TRANSMITTAL OF THE DRAFT PROPOSED ACTION MEMORANDUM FOR THE EAST TRENCHES PLUME - JEL-177-98

**Response to Kaiser Hill Comments on the
Draft Proposed Action Memorandum for the East Trenches Plume**

**Response to DOE Comments on the
Draft Proposed Action Memorandum for the East Trenches Plume**

Treatment System Profile
SCALE: 5 INCH = 1 FOOT

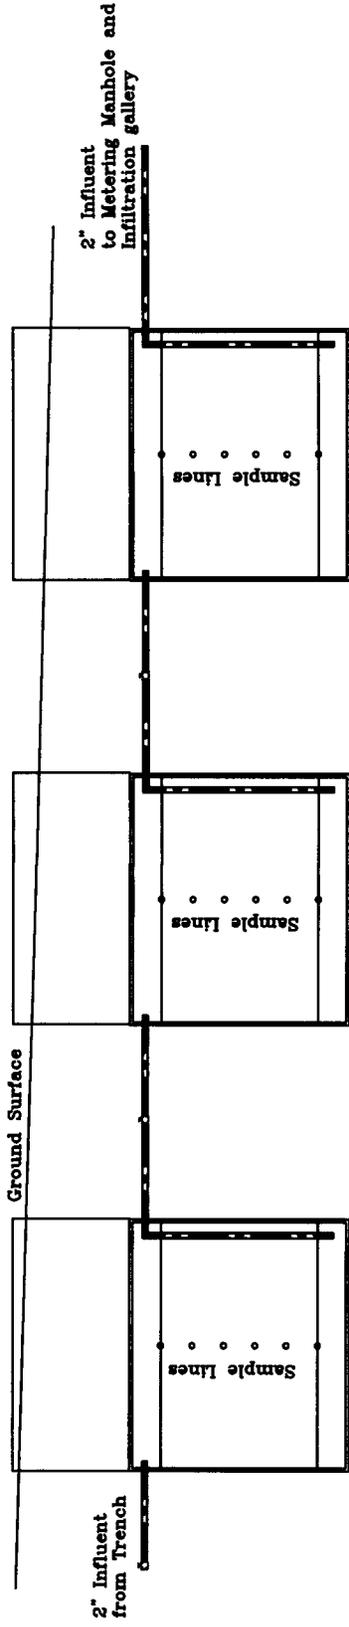
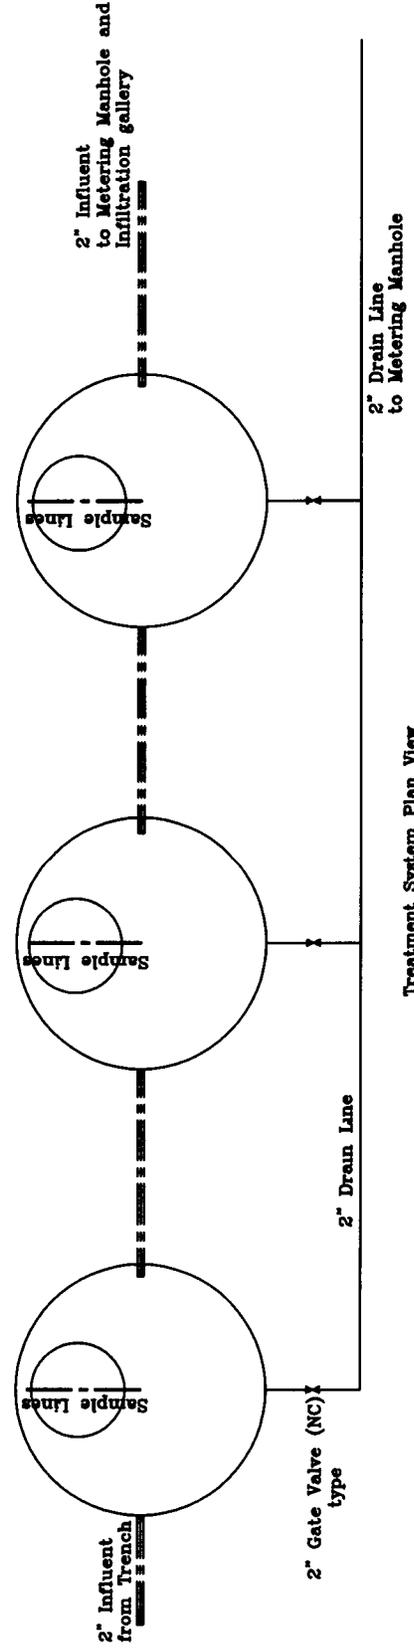
- 10 Page 20, Figure 9 Please indicate the location of this facility on the plan view figure

Response Added to figure

Figure 6
VOCs in Groundwater
East Trenches Plume Study Area

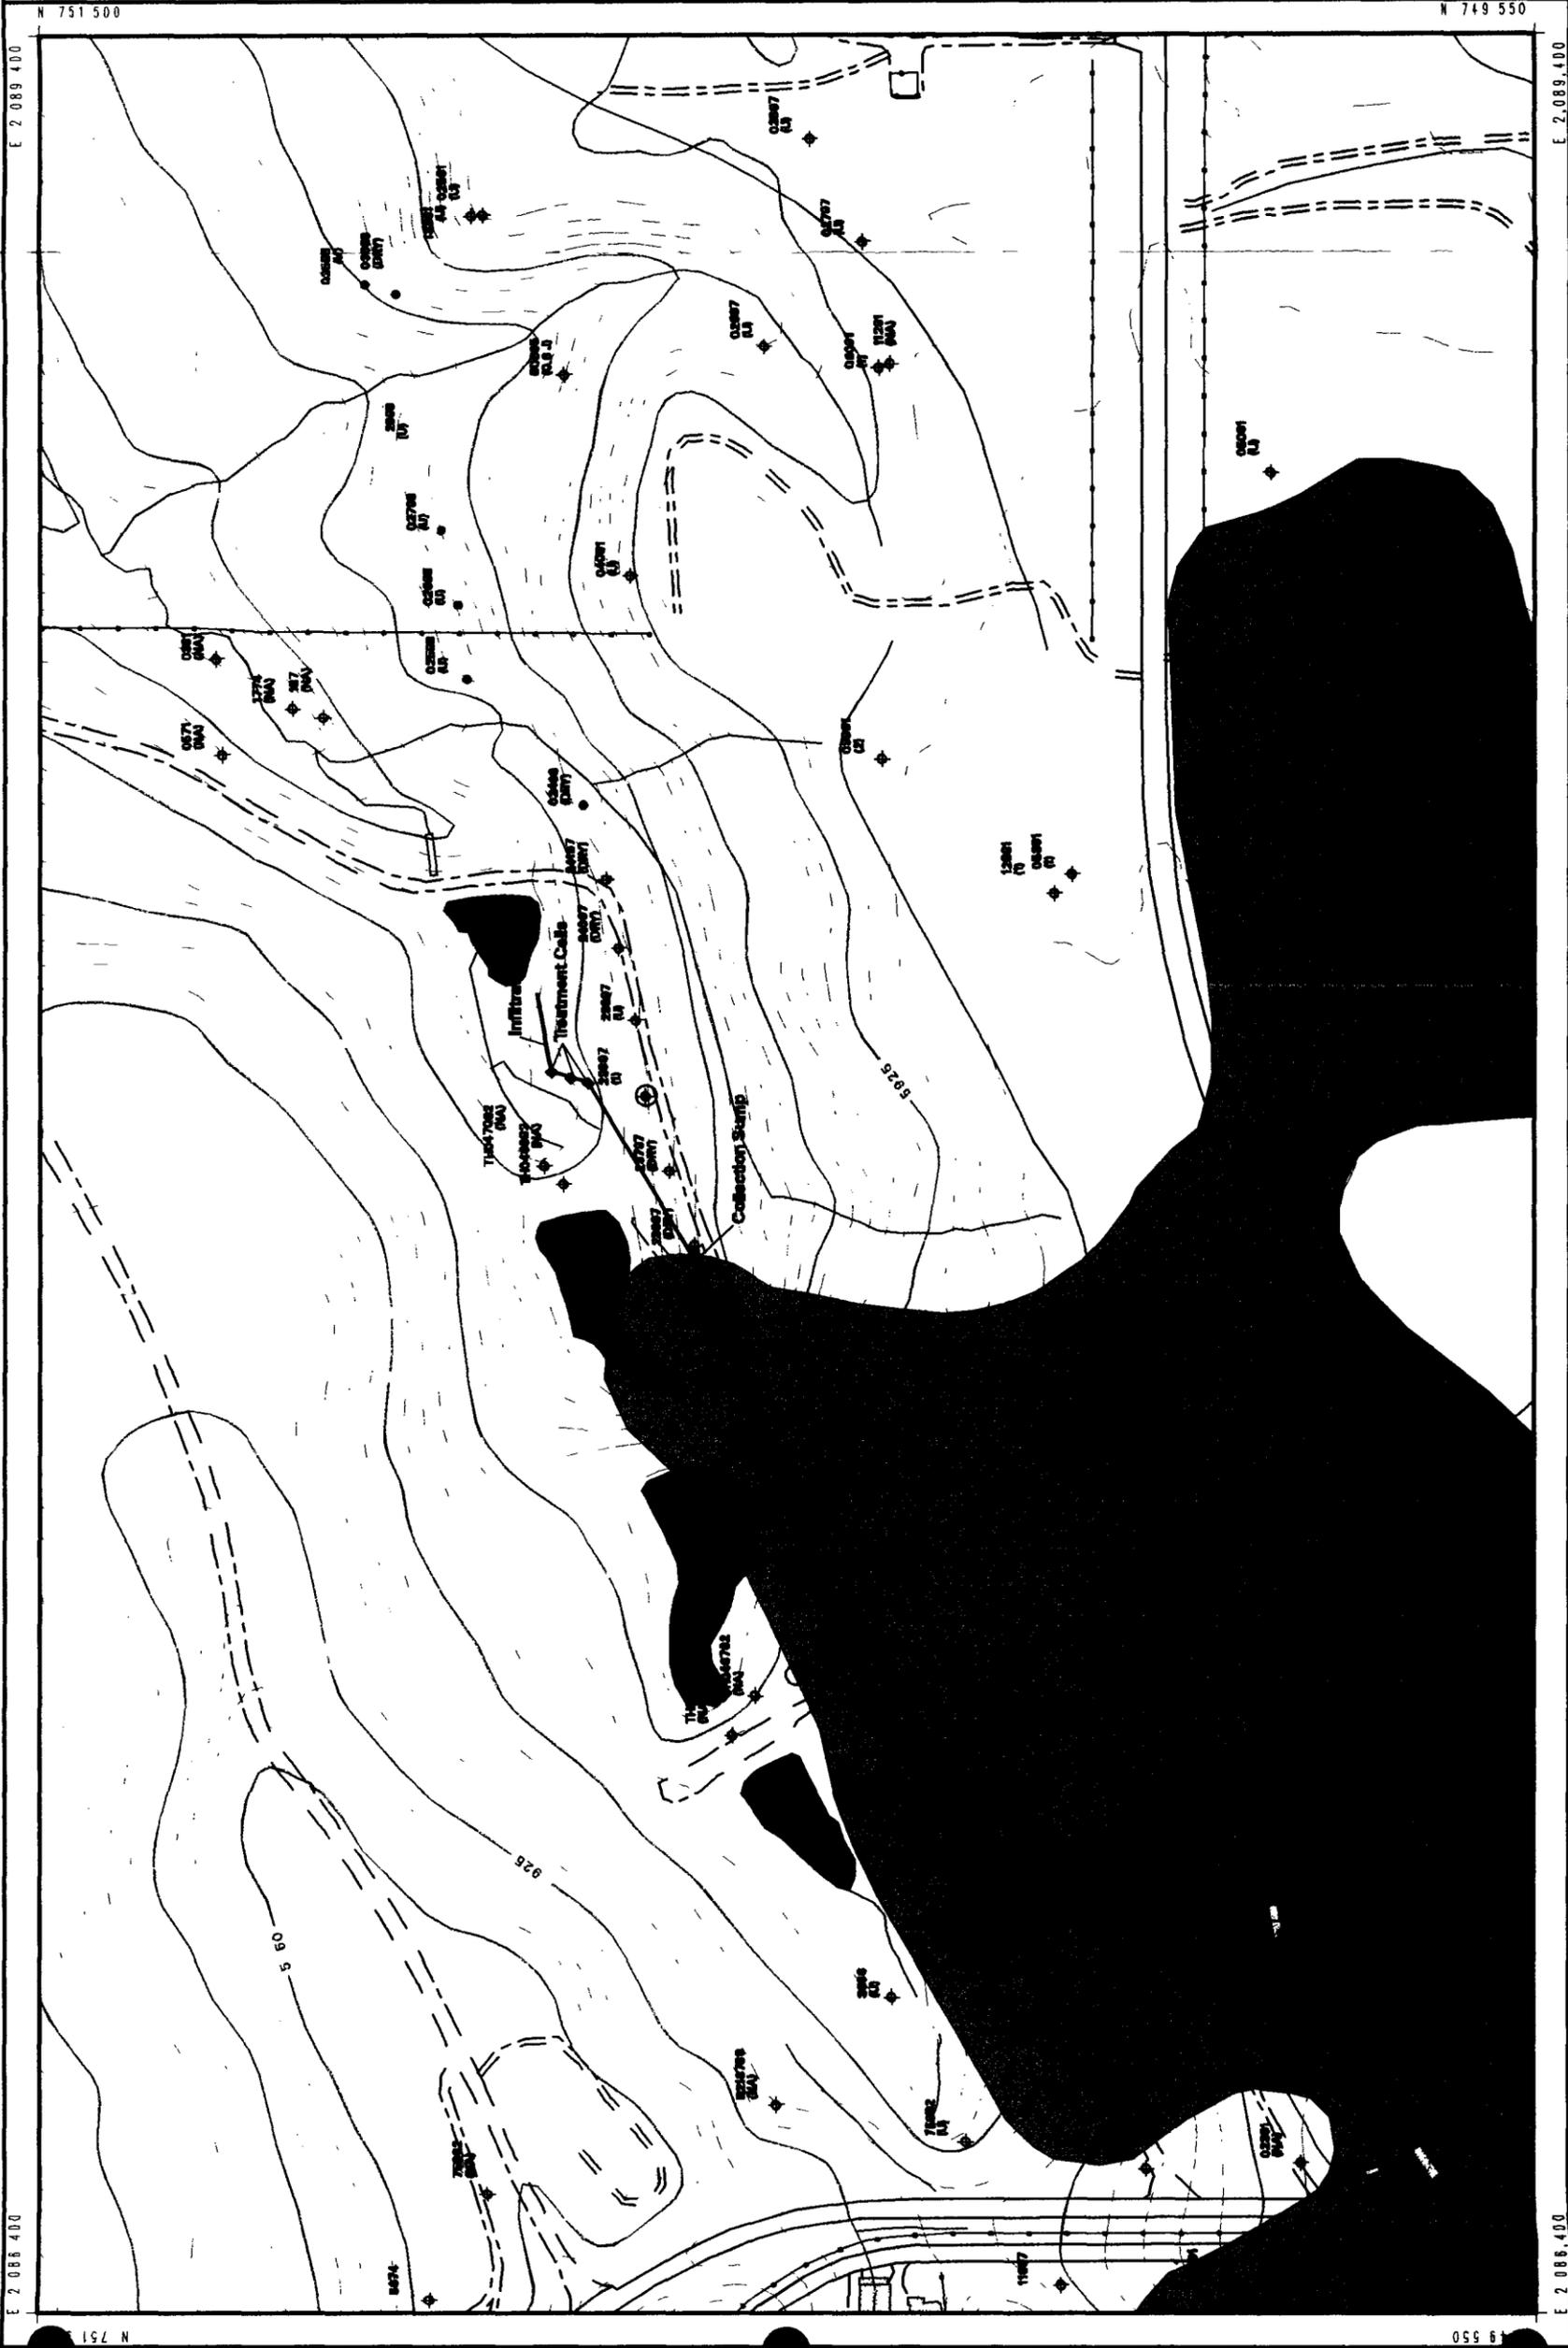
4. Page 13, Table 2. Please provide the units of concentration. The nomenclature at the bottom of the table (N/A) does not agree with that on Figure 6 (N/A and Dry).

Response These were added to Figure 6

Response: Corrected.

PREPARED FOR:	ROCKY FLATS ENVIRONMENTAL TECHNOLOGY SITE Golden, Colorado
TITLE:	Location and Proposed Depth of Collection System
FIGURE:	7

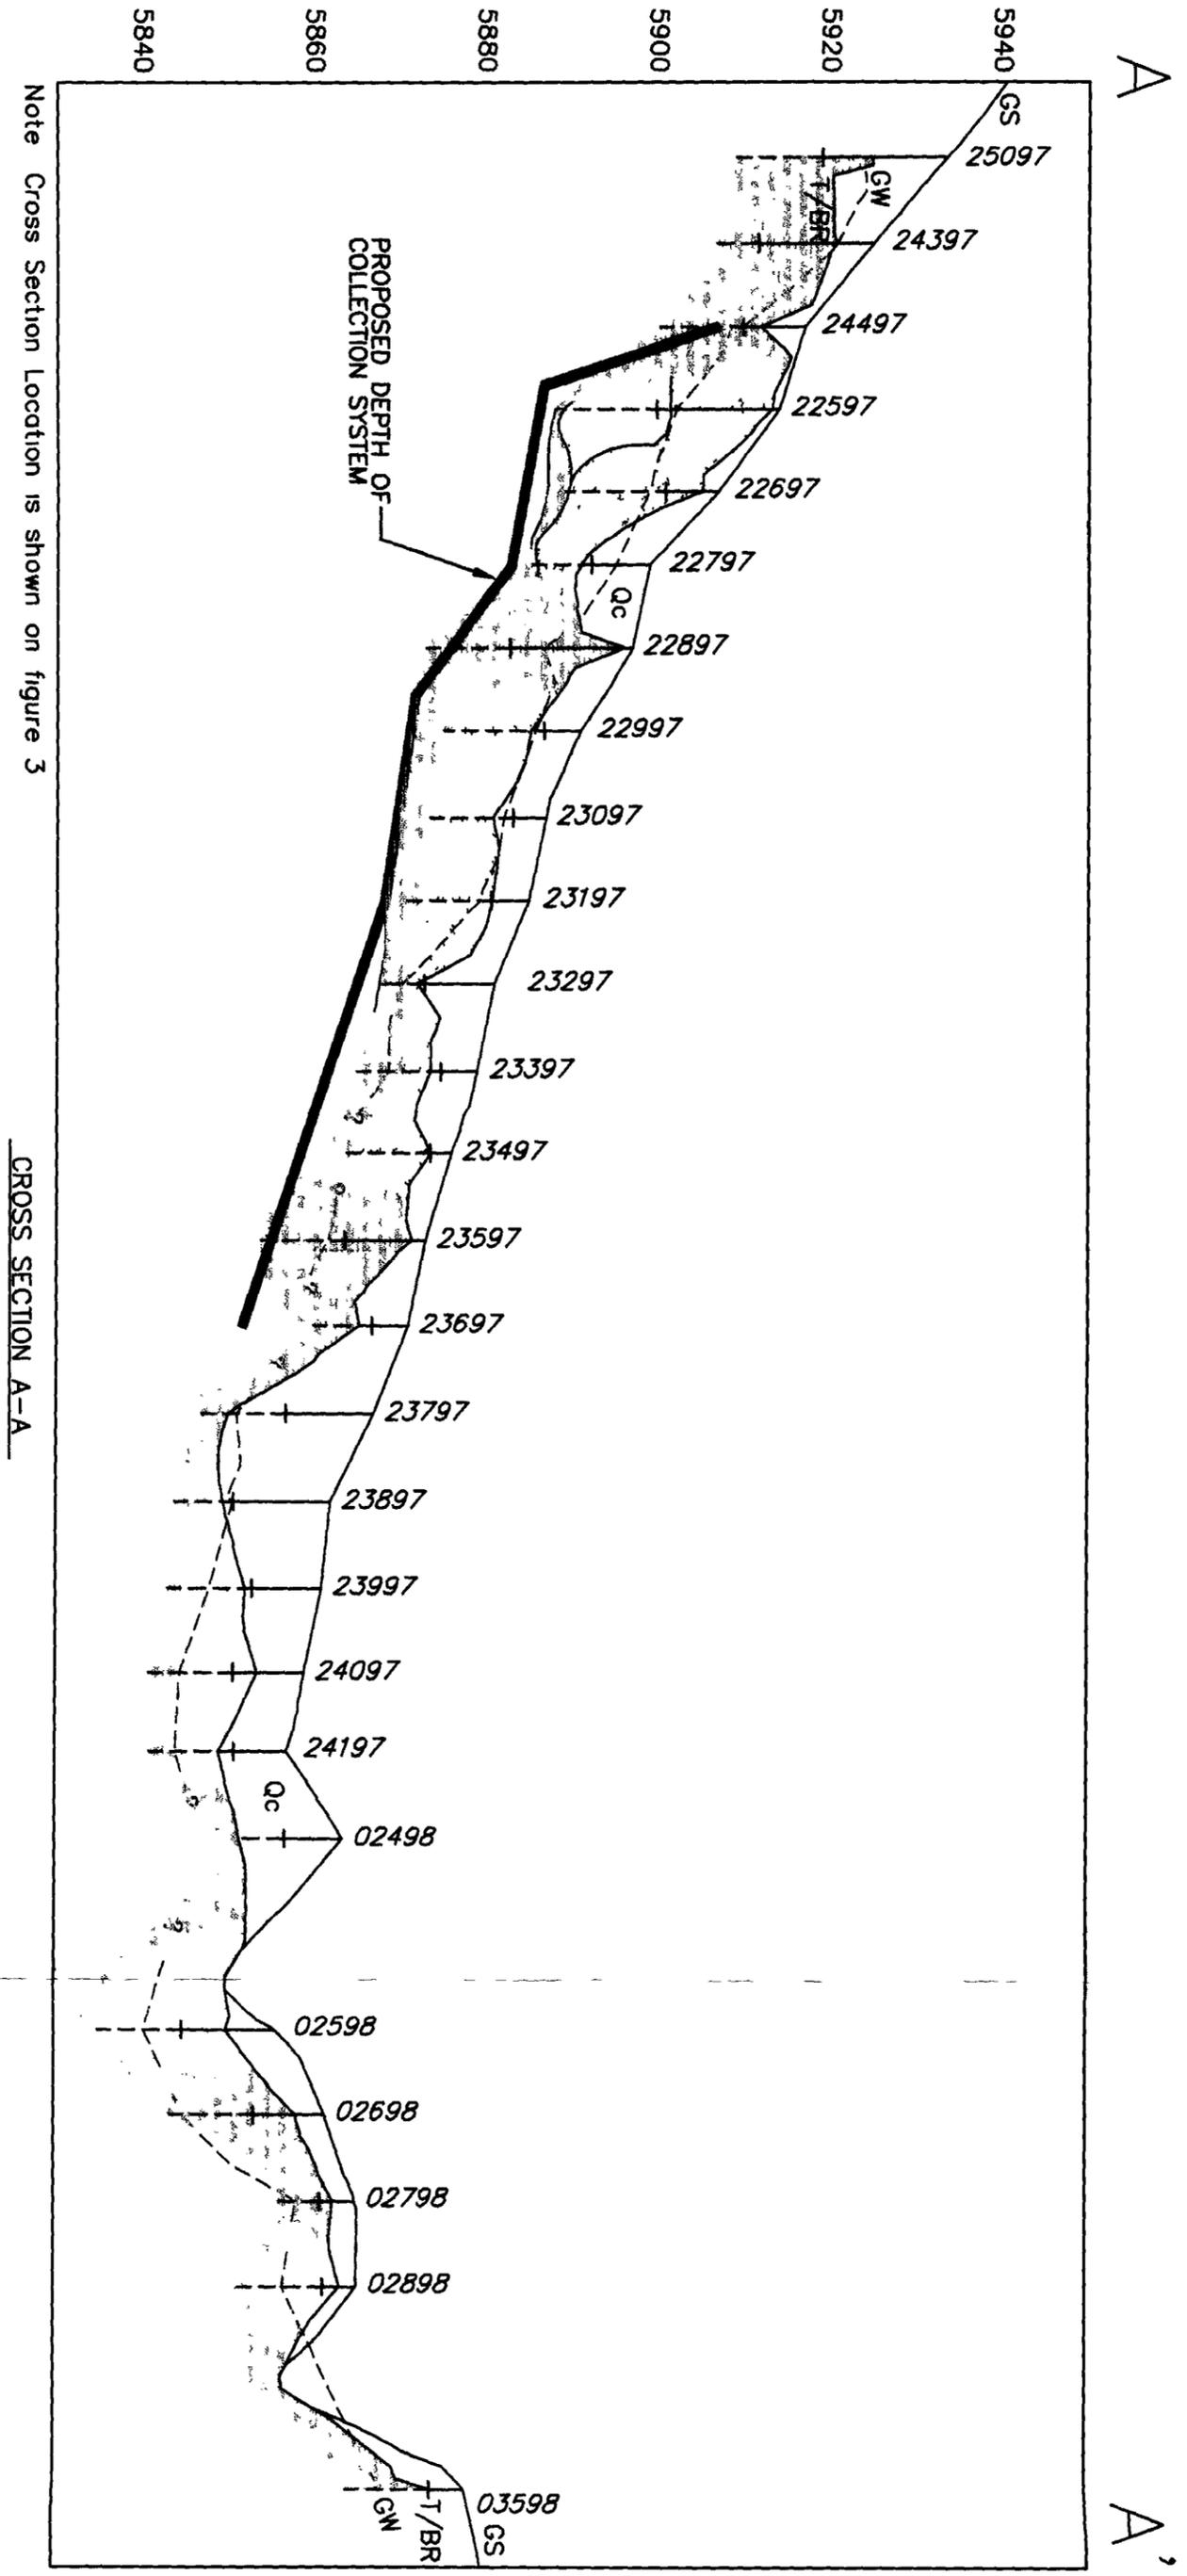
6. Page 15, Figure 7. Please reference the Figure illustrating the map view of this cross section. Please label the bold red line on the figure.

Response: References were made.
